**UNITED STATES OF AMERICA  
NUCLEAR REGULATORY COMMISSION**

In the Matter of	)	
	)	Docket ID NRC-2013-0070
	)	
SOUTHERN CALIFORNIA EDISON CO.	)	
	)	
(San Onofre Nuclear Generating Station,	)	
Units 2 and 3)	)	May 16, 2013
	)

**FRIENDS OF THE EARTH’S AND NATURAL RESOURCES DEFENSE COUNCIL’S  
COMMENTS IN OPPOSITION TO  
PROPOSED *NO SIGNIFICANT HAZARDS CONSIDERATION* DETERMINATION**

1-Figure-1 Fatigue data used by MHI to determine tube fatigue life. The cycle independent line represents the endurance limit, MHI used an endurance limit of 13.6ksi. Attachment 4, P 16-2. data for smooth specimen.

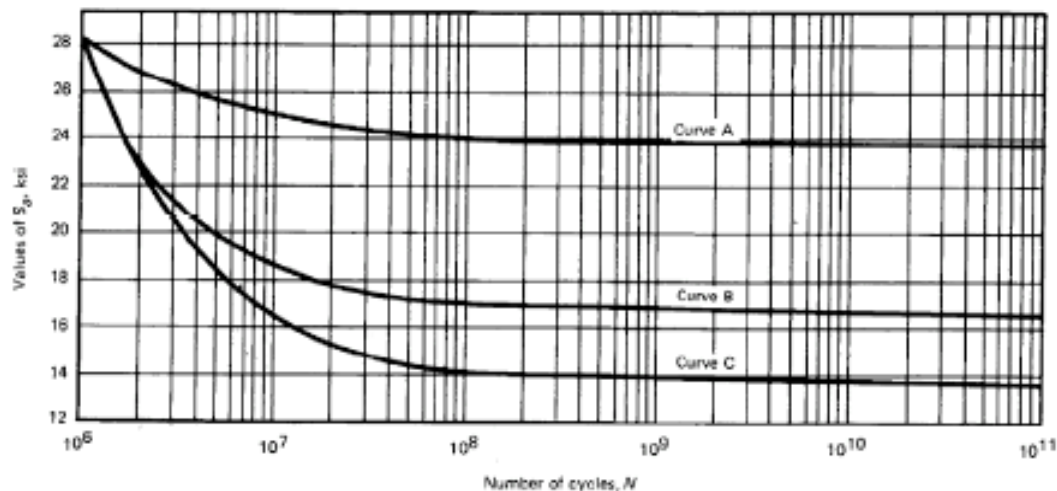
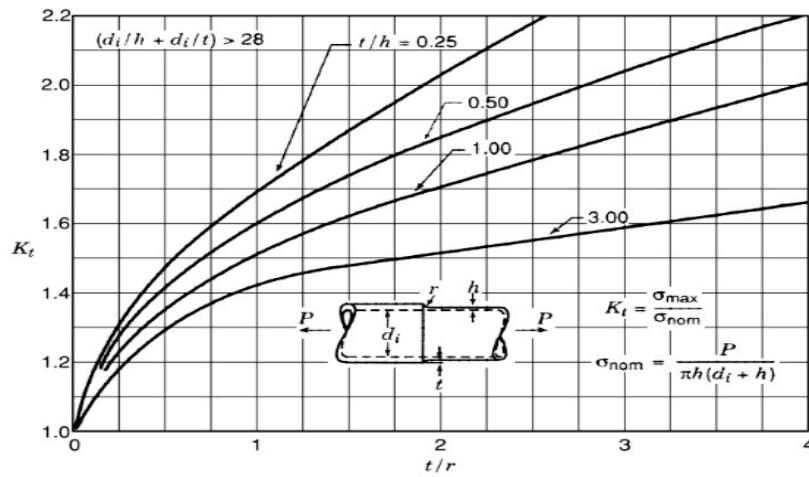
results have been published in numerous publications to guide designers in selecting the particular fillet for a given application. MHI used a design chart, Figure 2, for a tube in pure tension to determine the stress concentration factor  $K_t$ . Assuming an undisclosed value for the fillet radius and the value of the parameter ( $t$ ) MHI concluded that  $K_t$  was less than 1.5 when  $t/r = 1.33$ . These numbers indicate that MHI used a value of  $t/h$  that exceed unity. Had MHI assumed smaller values for  $t/h$ , and a smaller radius,  $K_t$  would have exceeded 1.5 because  $K_t$  is sensitive to the assumed geometry of the fillet. MHI selected an arbitrary geometry, which is not valid, and for this reason they only obtained an unrealistically low value for  $K_t$ .

Bounding calculations would require that the ASME design stress used by MHI (13.6 ksi) be lowered to account for surface finish. It is not clear however that the introduction of both a stress concentration and surface finish correction simultaneously would not be overly conservative. Since no data was found in the literature where both a sharp corner and adjacent rough surface, a surface finish correction was not included in the present assessment. In that sense, the application of a concentration factor of 5 together with curve C of Figure 1 may not be conservative.

Comparison of the actual ASME curve with those that were reproduced by SCE/MHI shows that SCE/MHI incorrectly labeled the data to indicate that it was generated for tubes and was limited to operation below 800 F. The data would not be applicable to severe accidents, which were discussed above. It is not clear why SCE/MHI mislabeled the ASME figure to indicate that it was generated for tubes.

Figure 4 – MHI description of wear shape at tube/ AVB contact point. Attachment 4. P. 10-20

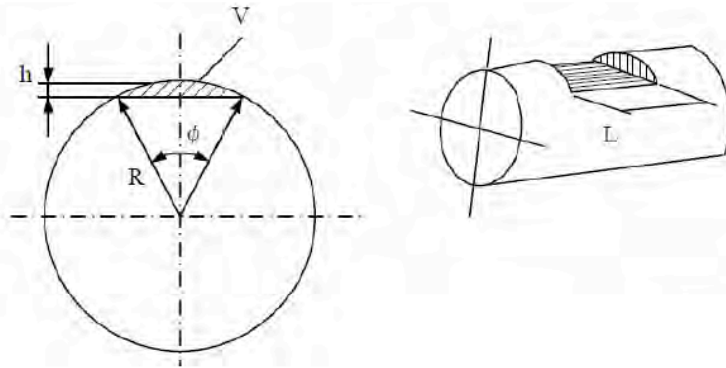
In their report (Appendix 16), SCE/MHI stated that because the AVB and the tubes are imbedded in each other the condition of the surface cannot be seen. Given that the respective surfaces have been sliding and impacting each other it is difficult to imagine how SCE/MHI concluded that such motion would produce polished surfaces. One must conclude that SCE/MHI disregarded the intent of the ASME code by not adjusting the Curve C stress to account for surface roughness.

Figure 5 - Schematic for determining a stress concentration factor  $K_t$  and reduced wall thickness of a tube due to double sided wear to a thickness (t) over an arc defined by  $\theta$

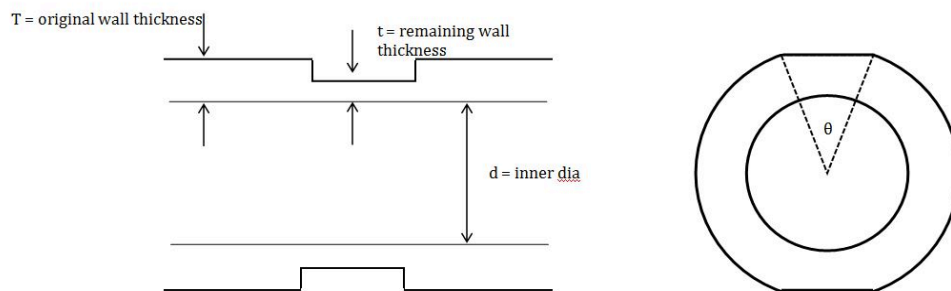
The model shown in Figure 5, represents more closely the wall thinned geometry than the one used by MHI in selecting the stress concentration factor. Since Figure 2 does not provide data for fillets with very small radius, it is necessary to consider a similar geometry giving  $K_t$  values for small radii. In Figure 6 (a special case of Fig 2,  $d_i = 0$ ),  $K_t$  is plotted for very small radii for bending -  $K_t$  values in tension are similar). Using a reported wear of 35%TW.  $K_t$  is calculated as follows:

Figure 6 – Stress concentration used in the present analysis. W.D. Pilkey, Peterson's Stress Concentrations Factors, John Wiley and Sons 1997. (Similar  $K_t$  values in tension -Peterson's Chart 3.4, and for internally pressurized vessel Chart 3.6 for a small radius)

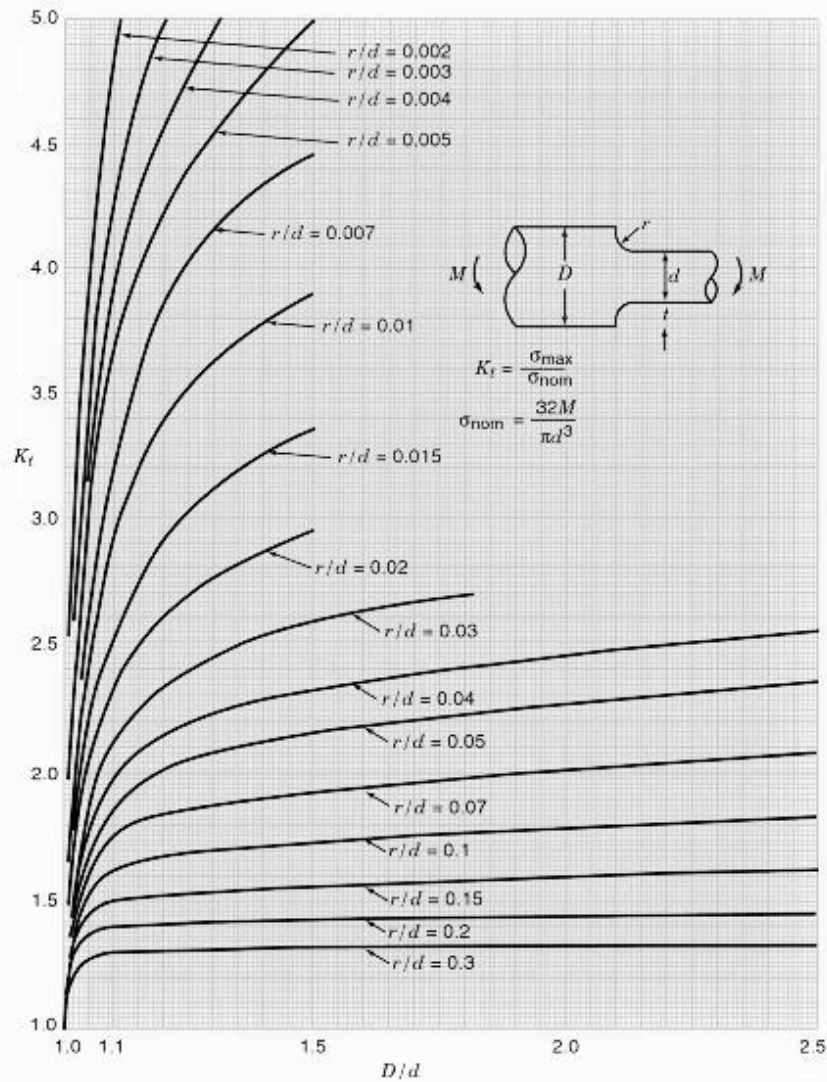
As a reality check on their fatigue model, one must wonder why SCE/MHI did not compare their calculated stress of 4.2ksi at San Onofre reactor Unit 2 with the stress (7.4-8.7 ksi and 4-10 ksi) that caused the rupture at Mihama and North Anna (Ref 6) respectively. Such a comparison should be made for each affected tube on the basis of the local velocity, steam quality, tube stiffness, natural frequency, and temperature gradients across the tube wall and  $\Delta P$ . SCE/MHI should show that the differences in conditions at Mihama and North Anna vs. conditions in San Onofre reactor Unit 2 account for the fact that Mihama and North Anna tube ruptures occurred at somewhat a higher stress. The SCE/MHI statement that stress concentrations at sharp discontinuities depend on whether the component is a hollow or solid, appears to be a new discovery in fracture mechanics. It is well established that stress concentration gradients at sharp notches decrease rapidly with the distance from the notch. In other words, the crack would be initiated at the tip of the discontinuity and is practically independent of the geometry further away. As the comment to Figure 6 indicate, examination of Peterson's charts clearly demonstrates this point.

Figure 7 – Effect on potential fatigue damage by correcting the MHI calculation

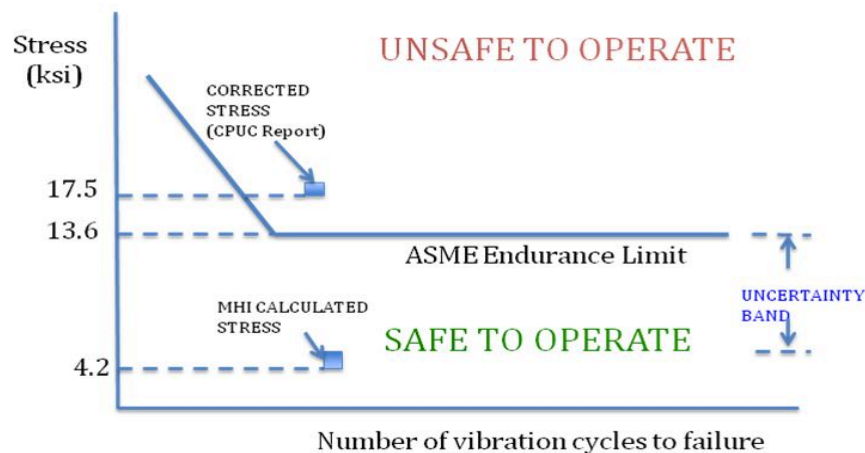
The impact of correcting the MHI calculations is demonstrated in Figure 7: it is self-explanatory. It should be noted that the stresses that ruptured the tubes at Mihama and North Anna (Ref 5), about 7.4 to 8.7ksi and 4 to 9ksi respectively was within the error band indicated in the Figure. The ruptures at Mihama and North Anna occurred due to support plate/ tube interaction not due to AVB/tube interaction.

FIGURE 10– This has been duplicated to show why SCE /MHI concluded that the “vibration are well below the stresses that would cause fatigue failure” as illustrated in Figure 7.

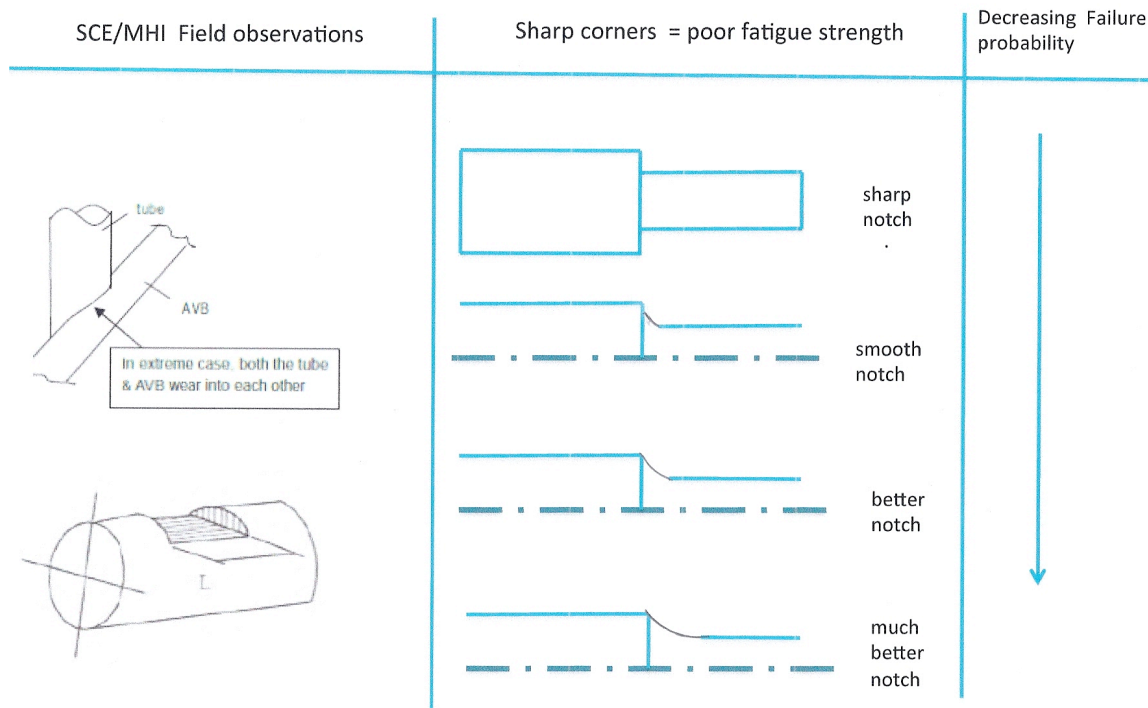
Figure 10 above illustrates schematically how fatigue life is improved as the notch radius increases.

In light of the many unstated assumptions that SCE/MHI used in applying Figures 1 and 2 to the SONGS tubes, the statement that it is unrealistic to apply "stress concentration factor based on solid body geometry rather than the more realistic stress concentration factors for a cylindrical geometry applicable to the SONGS steam generator tubes." Is not appropriate. I used the solid geometry for convenience only. Extrapolation of the tube data in Figure 2 to sharp corners ( $r=0$ ) would have resulted in the same stress concentration factor.
